PROJECT NUMBER: 1002739
 APPLICATION NUMBER: 04DRB-00894

AMENDMENT #2

ANDERSON HEIGHTS

AMENDED SITE DEVELOPMENT PLAN FOR SUBDIVISION & UTILITY PLAN

Designed: GJK Drawn: RDQ Checked: DMG Sheet 1 of 4
 Scale: 1" = 100' Date: 6-3-04 Job: A03080

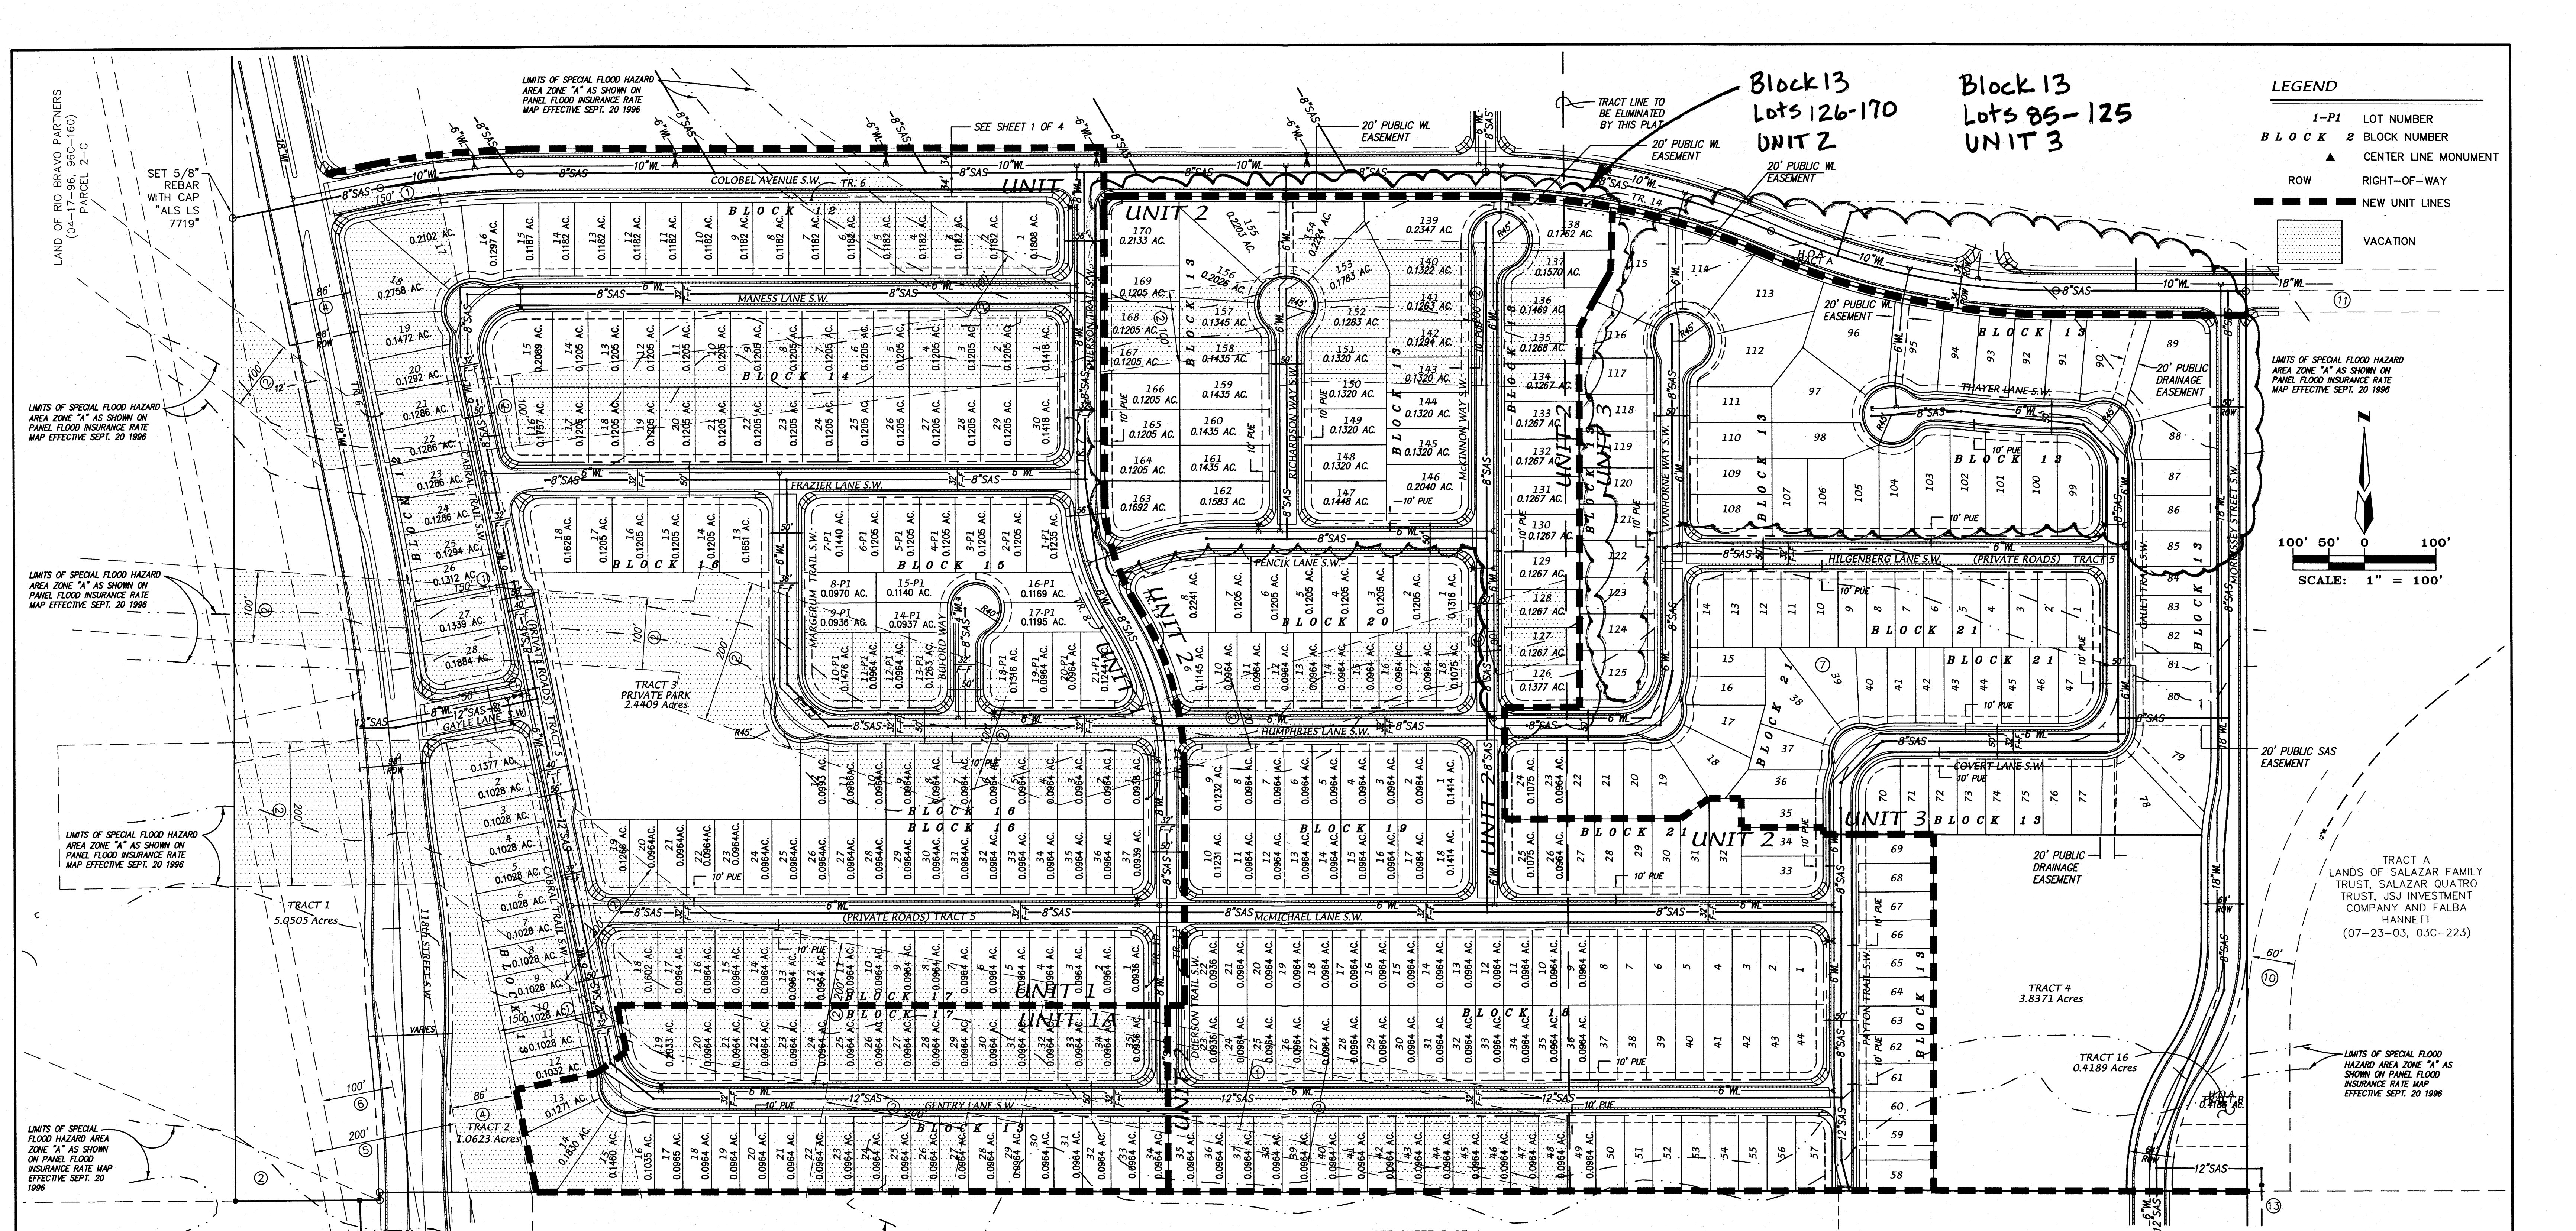
Purpose for Amendment #2
 Eliminate 7 lots on McKinnon Way in Unit 2 which renumbered the Lots in Block 13.
 Eliminate 10 lots in Unit 3 (not part of the Site Plan)
